STREAM FIFTEEN APARTMENTS
605 15TH AVENUE EAST

DESIGN REVIEW RECOMMENDATION
SEPTEMBER 18, 2013
DPD #3014339

ADDRESS: 605 15th Avenue East
DPD PROJECT #: 3014339
OWNER: Stream Real Estate
APPLICANT: Nicholson Kovalchick Architects
CONTACT: Gary Oppenheimer, AIA

SIGNAGE CONCEPT

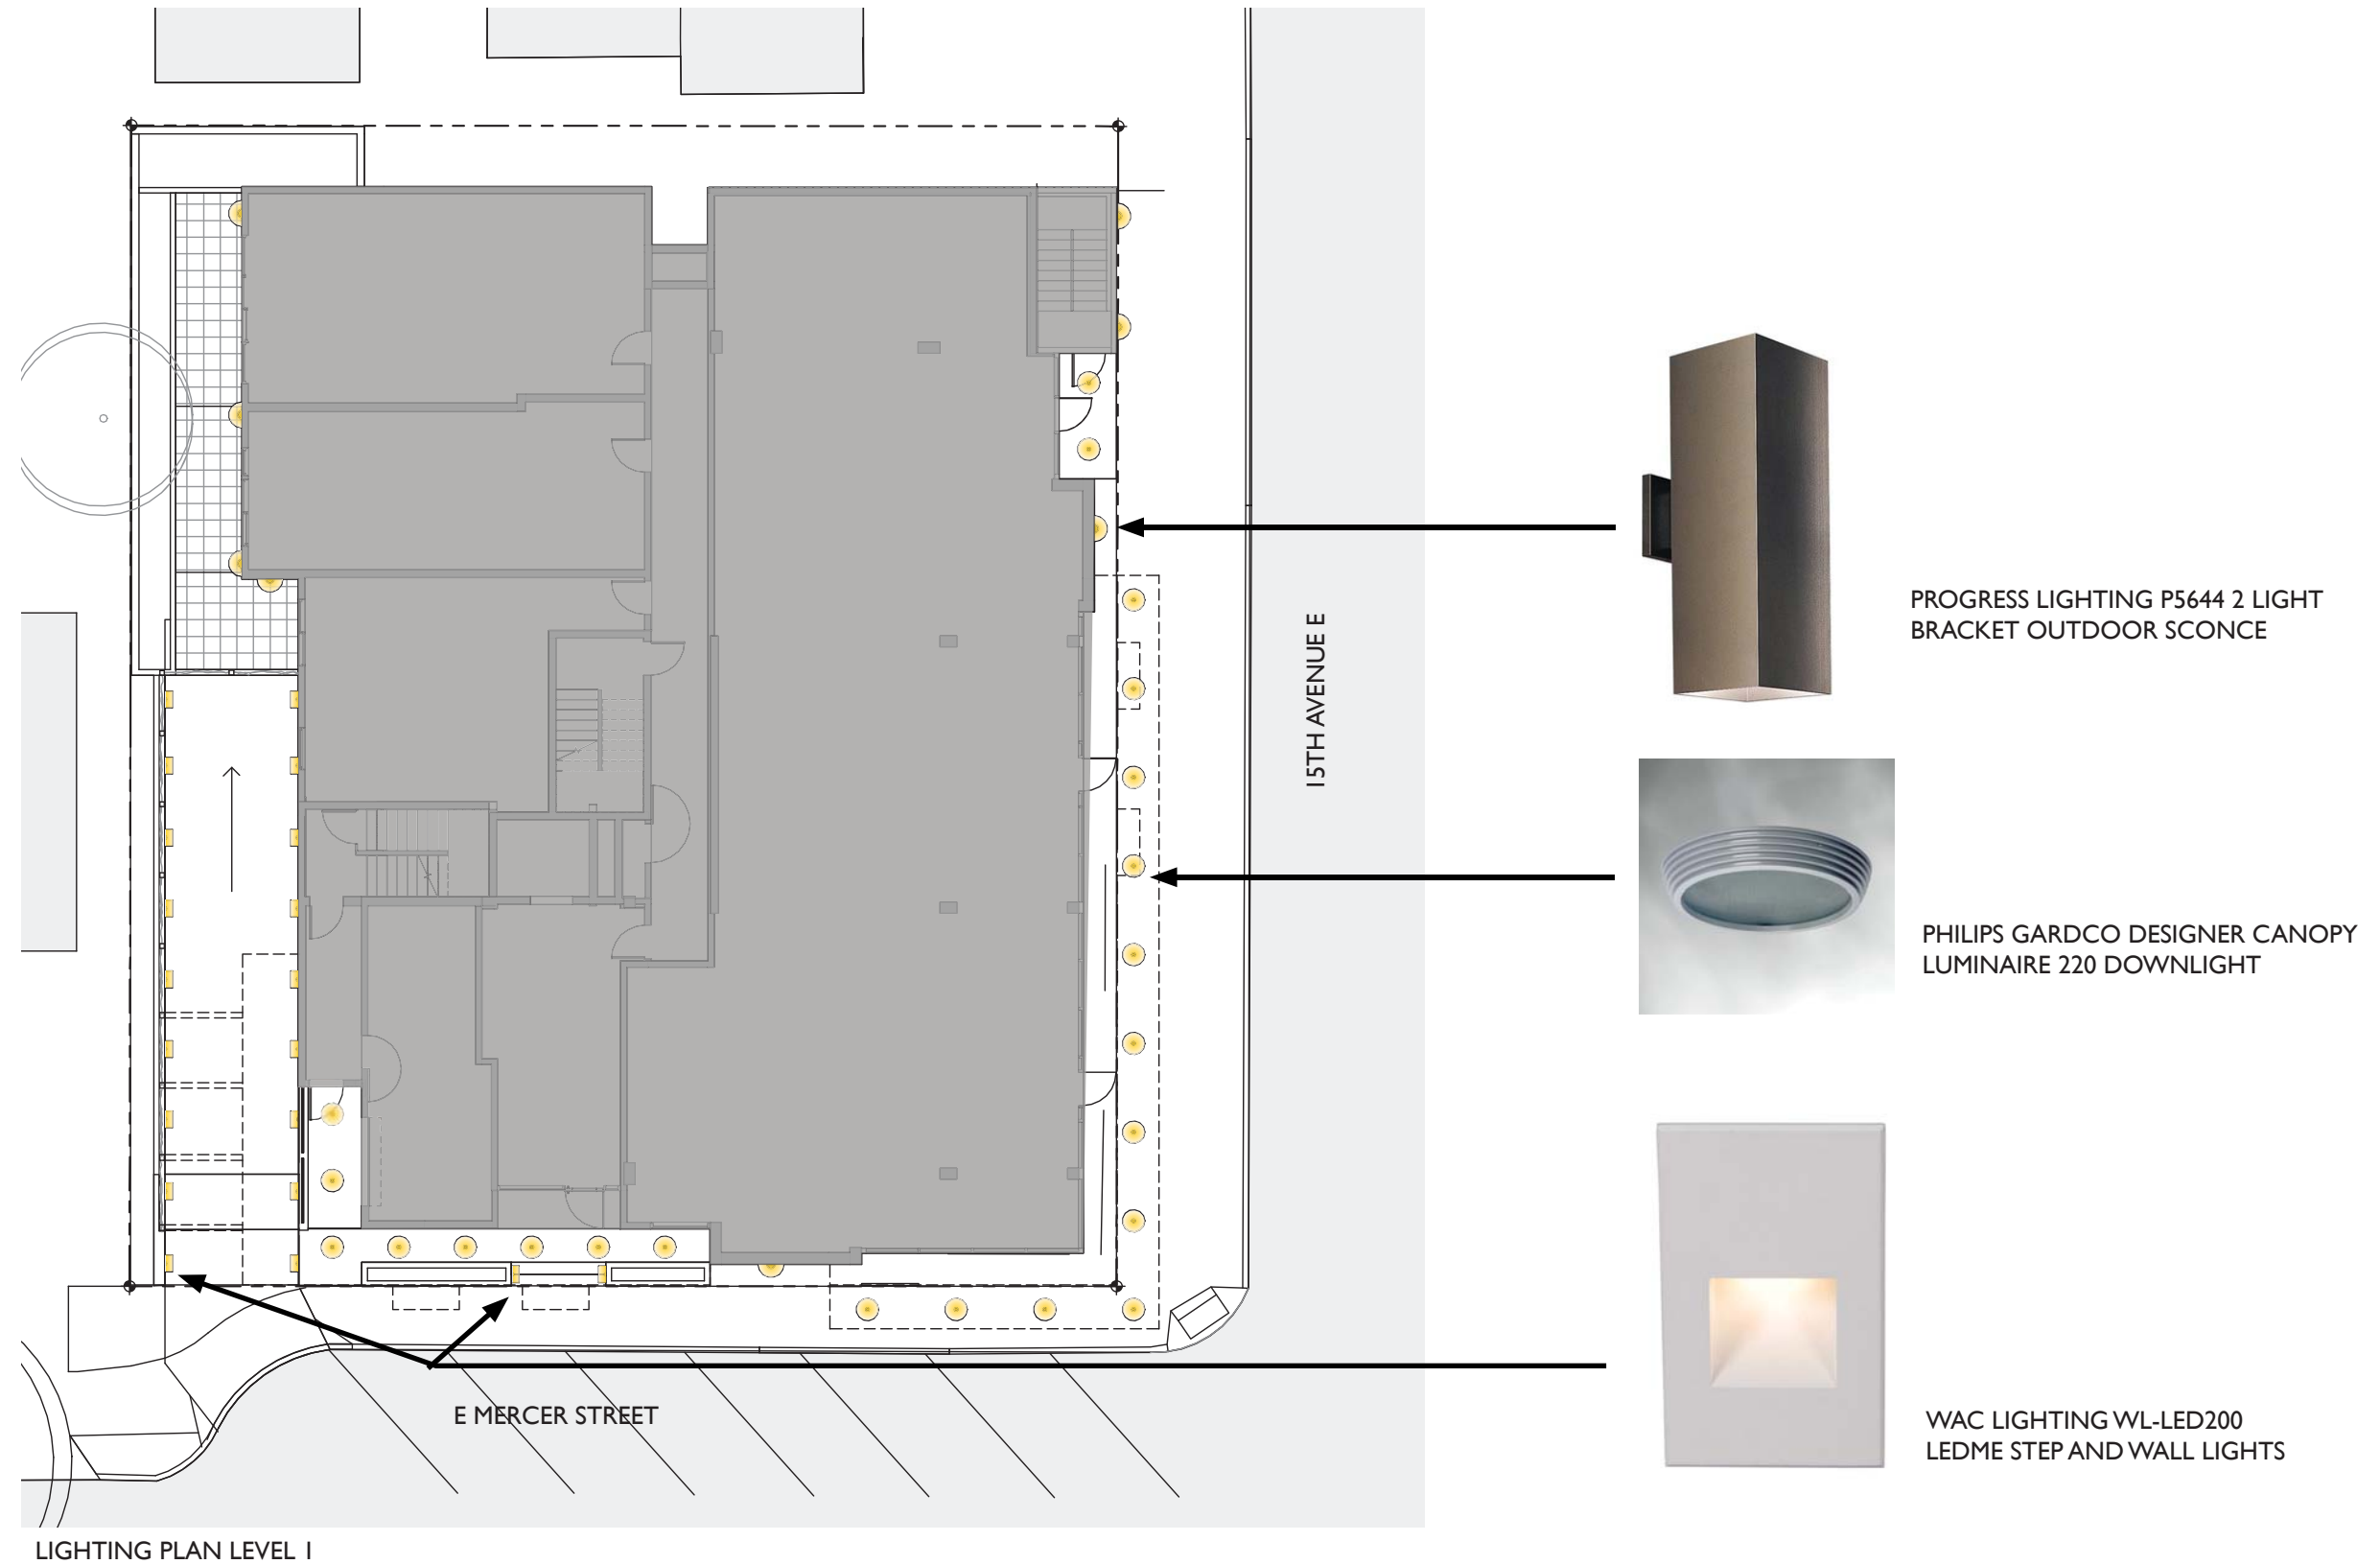
At the Early Design Guidance Meeting, the Board did not discuss this guideline but indicated it was of highest importance.

A general retail signage concept will be presented at the Recommendation meeting. The project intends to have high quality retail stores with signage consistent with the overall architectural quality of the building and in keeping with the neighborhood guidelines. The signage will follow the precedent of other retail along 15th Ave E.

DEPARTURE #1 ABUTTING CORNER SETBACK

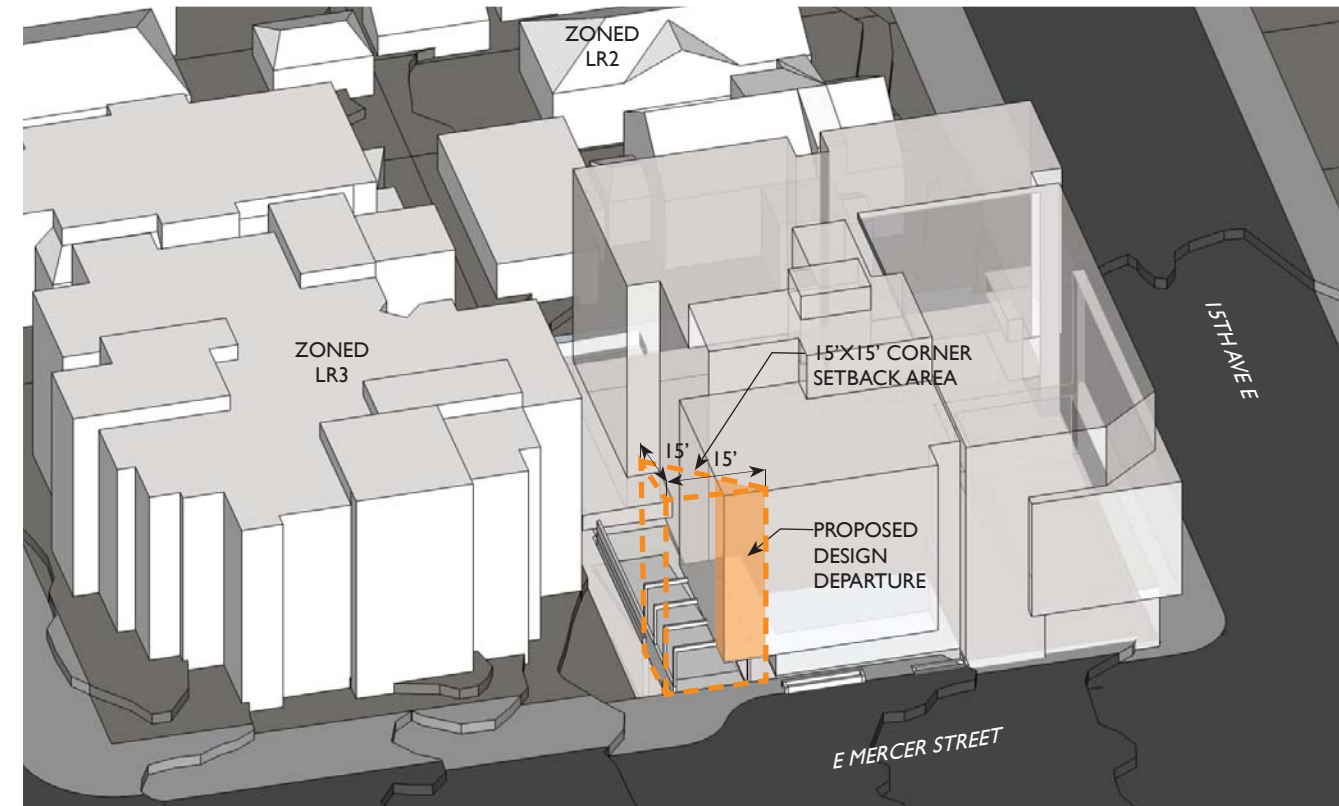
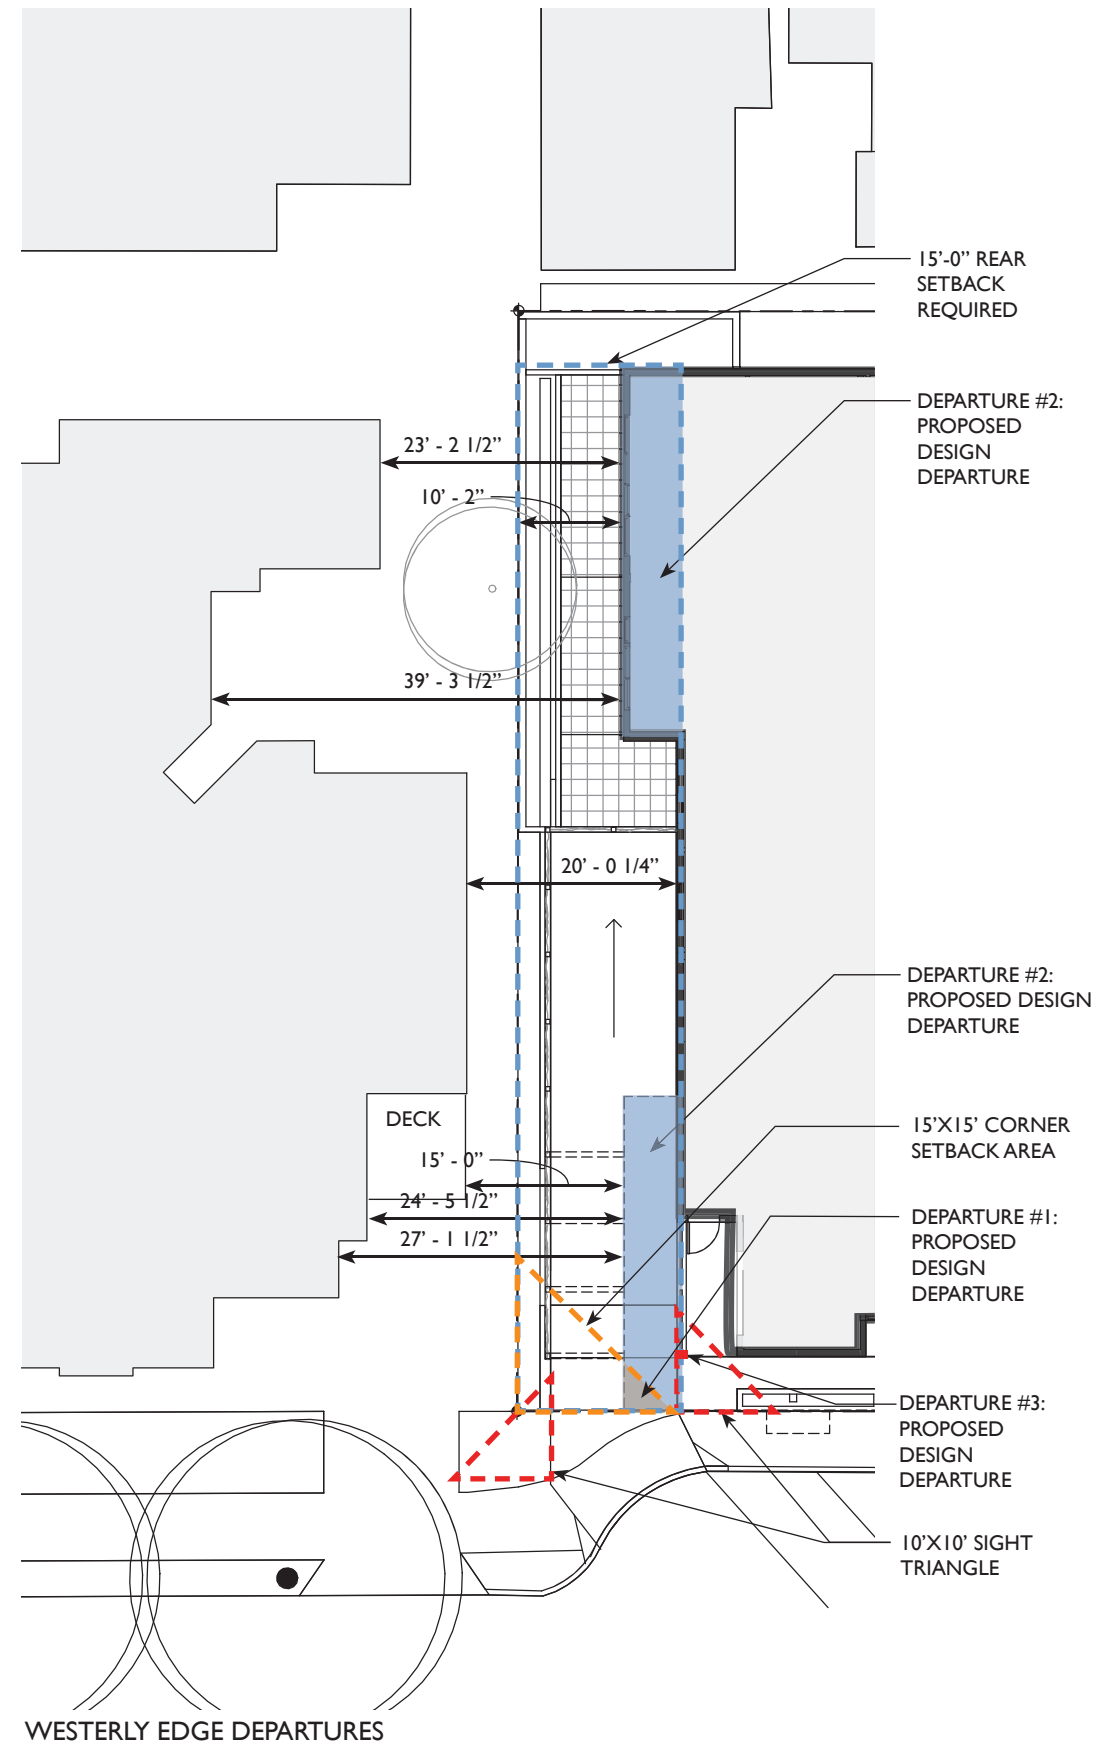
At the Early Design Guidance Meeting, the Board spent much time discussing their concern with the requested departures from the upper level residential setbacks along the north and west lot lines. They indicated that the relationship of the proposed structure should better respect the existing residential structure to the west, especially as the existing structure has balconies. The Board also discussed the relationship to the structure to the north, indicating that the proposed design seemed to show more respect for this property than the structure to the west.

The Board indicated they were not inclined to support a residential setback departure along the west property line. The Board has concerns about the residential setback departure along the north lot line but may be inclined to grant the departure if the north façade is designed well (see Guidelines C-2 and D-2). They also encouraged the applicant to consider moving the ground level closer to the north property line.

The project has revised the northern setback to be 5'-6" to eliminate the gap between the building and the laurel hedge. The existing laurel hedge is to remain per a settlement agreement with the property owner to the north. The setbacks along the west property line have been revised to maintain a minimum 20' dimension between the residential structure to the west and the proposed project. The western façade of the project is modulated to correspond to the existing building to the west and setbacks along the west property line vary from 10' at the north 35', 15'-2" at the center 34' and 10'-2" at the southern portion of the western façade. Windows and decks have been located to minimize privacy conflicts. Reflecting the intent of the code, a minimum 15' distance (including balconies) is proposed from structure to structure.

The project has revised the northern setback to be 5'-6" to eliminate the gap between the building and the laurel hedge. The existing laurel hedge is to remain per an adverse possession claim settlement agreement with the property owner to the north. The setbacks along the west property line have been revised to maintain a minimum 20' dimension (excluding balconies) between the residential structure to the west and the proposed project, reflecting the intent of the land use code. The western façade of the project is modulated to correspond to the existing building to the west and the setbacks
